**S-TYPE**

S501-21

SERVICE**TECHNICAL BULLETIN**

**Sliding Roof One-Touch Issues –
Resynchronize Roof Panel & Reprofile Spring
– Repair Procedure**

ILLUSTRATION 1

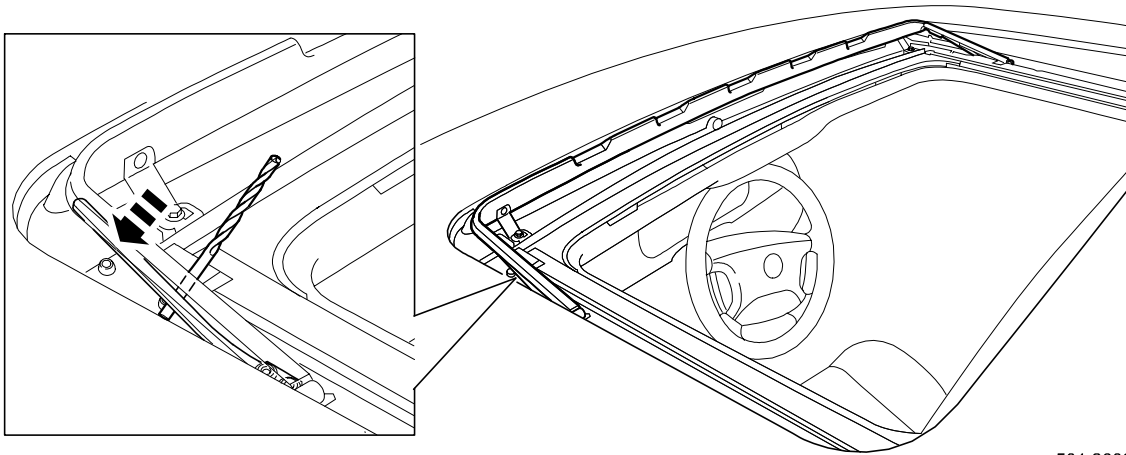
On some 2003-04 MY S-TYPE vehicles within the above VIN range, there is a possibility that the roof opening panel may not close on one-touch operation and may 'bounce back'. This condition may be caused by excessive strength of the wind deflector spring .

To address this concern the roof opening panel motor will have to have a de-synchronization and synchronization procedure carried out, and the wind deflector spring will have to be reprofiled.

4. On the left side of the vehicle, position the shank of a 4.0 mm twist drill under the base of the spring by the rivet head. Push the deflector down over the drill until it bottoms out to reprofile the spring (Illustration 1).
5. Carry out step 4 for the right hand side of the roof opening panel.
